Log # TXX-89577
File # 10010
908.3
Ref. # 10CFR50.34(b)

SUBJECT: COMANCHE PEAK STEAM ELECTRIC STATION (CPSES)
DOCKET NOS. 50-445 AND 50-446
ADVANCE FSAR SUBMITTAL
UPGRADE AND ADDITION OF CLASS 1E ELECTRICAL
EQUIPMENT IN THE PRIMARY PLANT VENTILATION
SYSTEM TO MAINTAIN NEGATIVE PRESSURE

Advance FSAR Change Regarding the Upgrade and Addition
of Class 1E Electrical Equipment in the
Primary Plant Ventilation System
to Maintain Negative Pressure

FIGURE 8.3-11-2

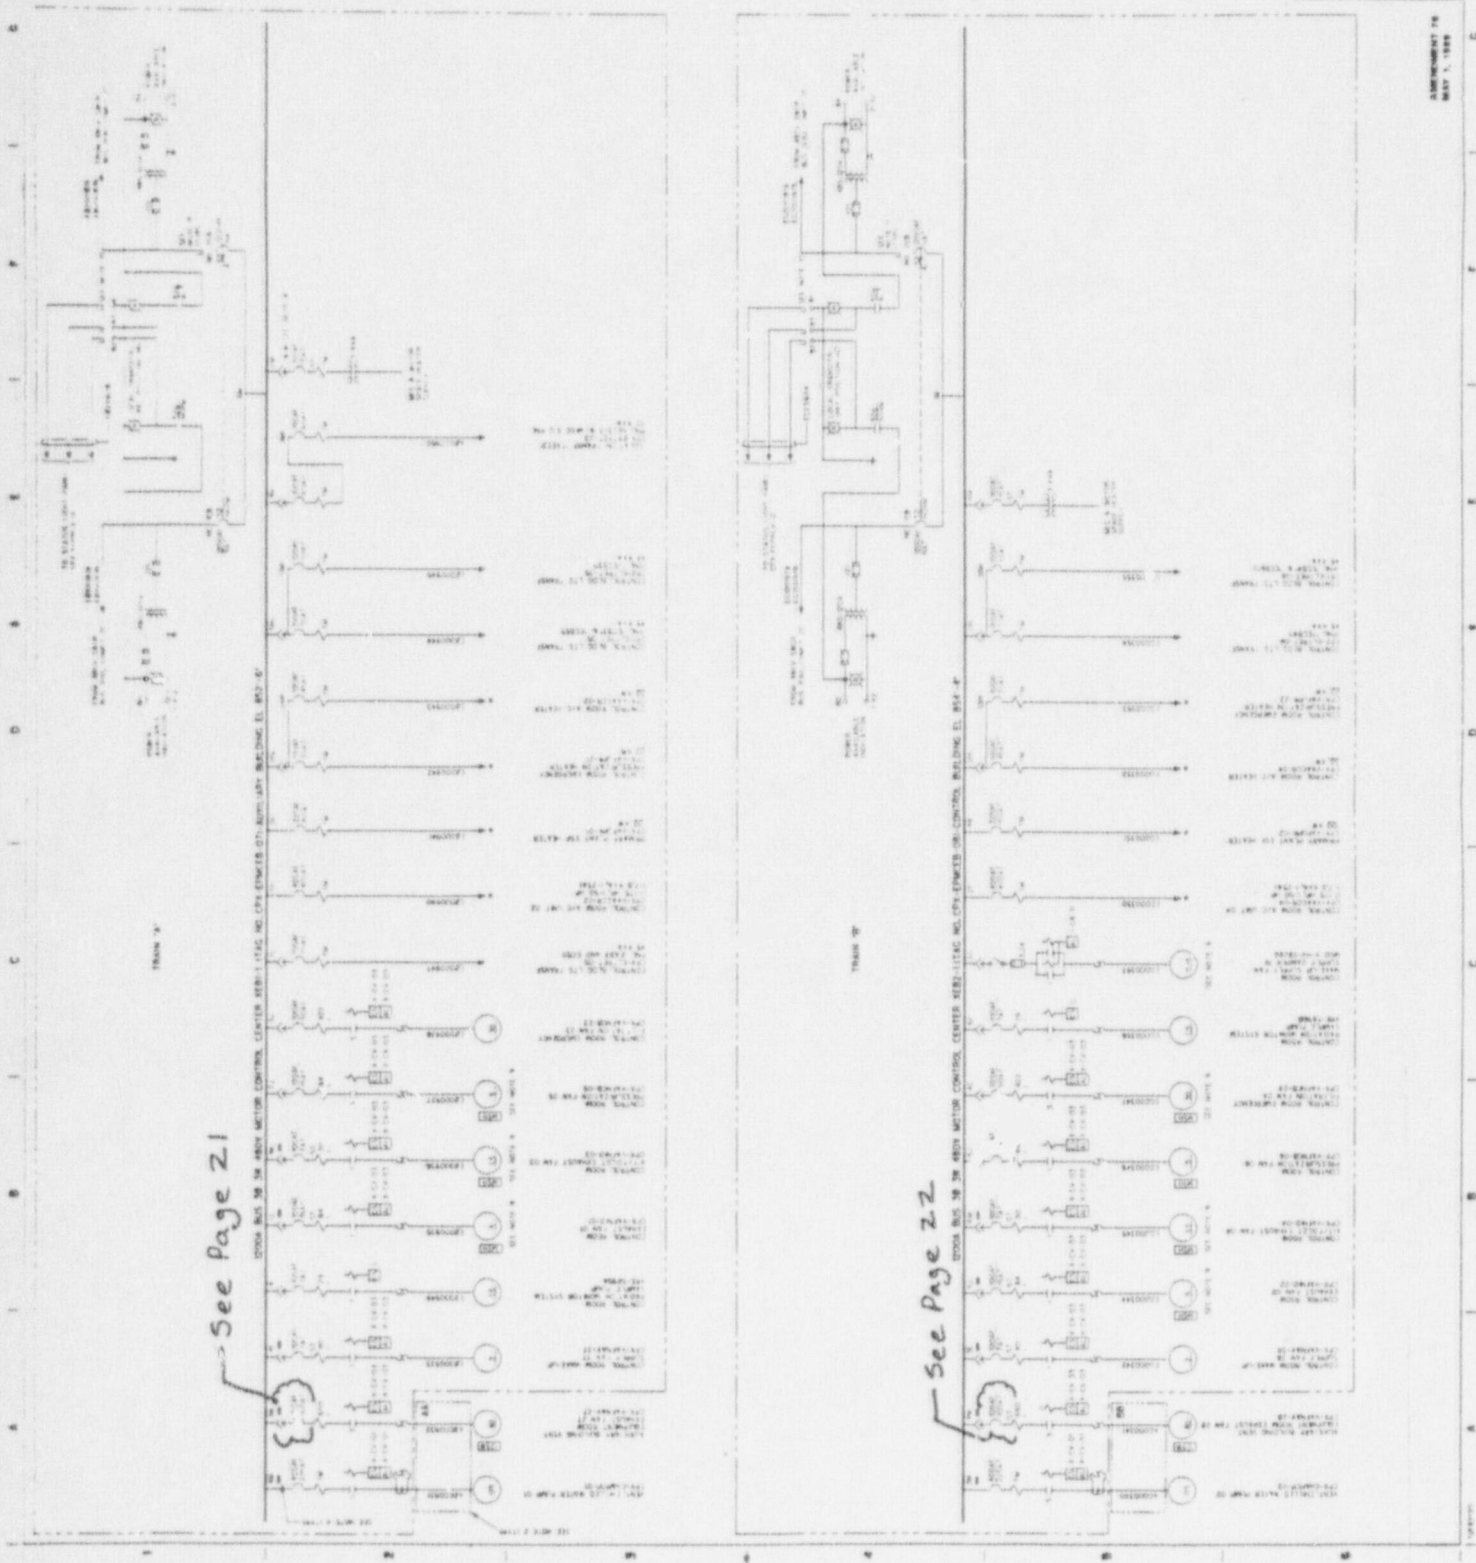
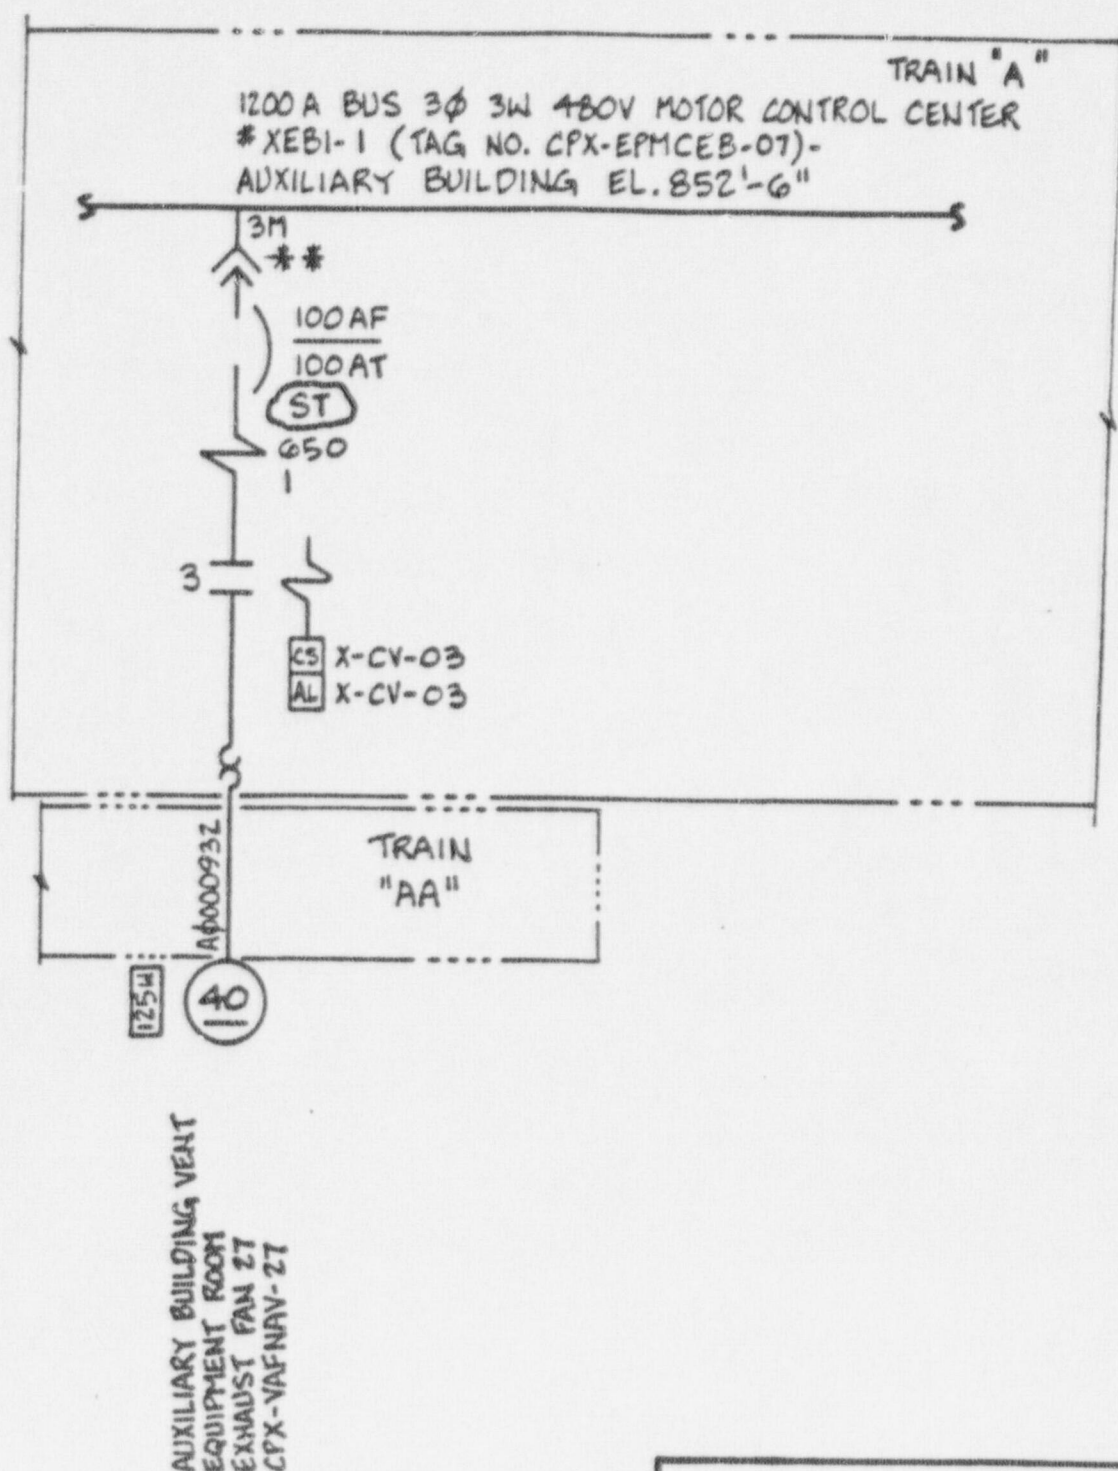
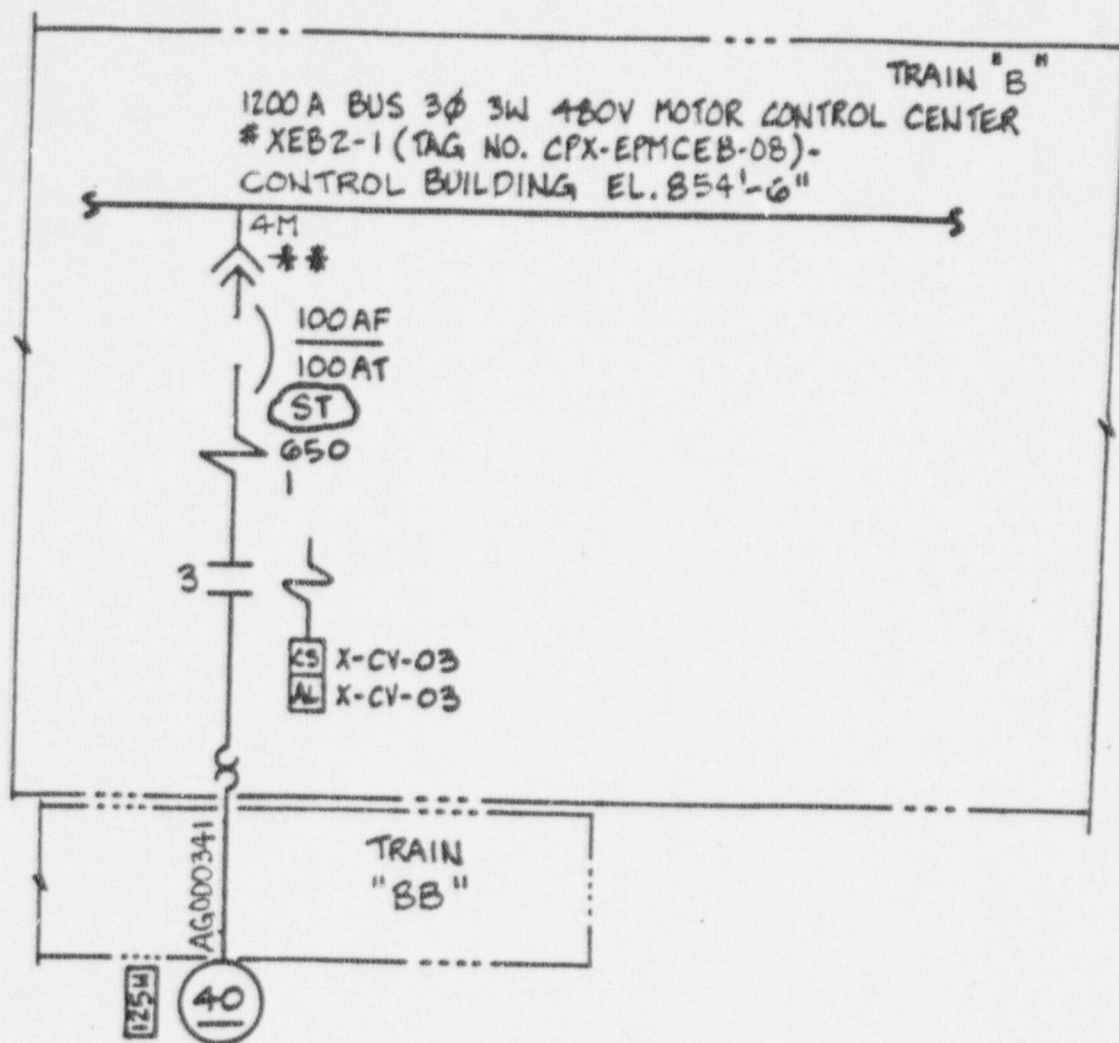
- 2 See Sheet No(s):2
Adds "S" signal trip to the breaker for the Auxiliary Building Ventilation Equipment Room Exhaust Fan (CPX-VAFNAV-27) in Compartment 3M of 480V MCC XEB1-1.
Revision:
The Primary Plant Ventilation (PPV) System has been modified by upgrading two installed PPV Exhaust Fans to

- 2 See Sheet No(s):2
Adds "S" signal trip to the breaker for the Auxiliary Building Ventilation Equipment Room Exhaust Fan (CPX-VAFNAV-28) in Compartment 4M of 480V MCC XEB2-1.
Revision:
The Primary Plant Ventilation (PPV) System has been modified by upgrading two installed PPV Exhaust Fans to Class 1E, removing the "S" signal trip from the fans' circuitry, upgrading the fans' power cables to Class 1E, and adding shunt trip devices to certain non-Class 1E Exhaust/Supply Fan circuitry. The two upgraded PPV Exhaust Fans and their power cables were originally procured as Class 1E and the power cables are routed in Class 1E raceways. The addition of the shunt trip devices provides electrical isolation between the non-Class 1E PPV Exhaust Fans and the Class 1E power source consistent with Reg. Guide 1.75 and FSAR Section 8.3. The shunt trip devices will cause the fans to trip upon receipt of an "S" signal. The purpose of the modification is to provide additional margin relative to the negative pressure required to be achieved and maintained in the negative pressure envelope during a LOCA or LOOP.
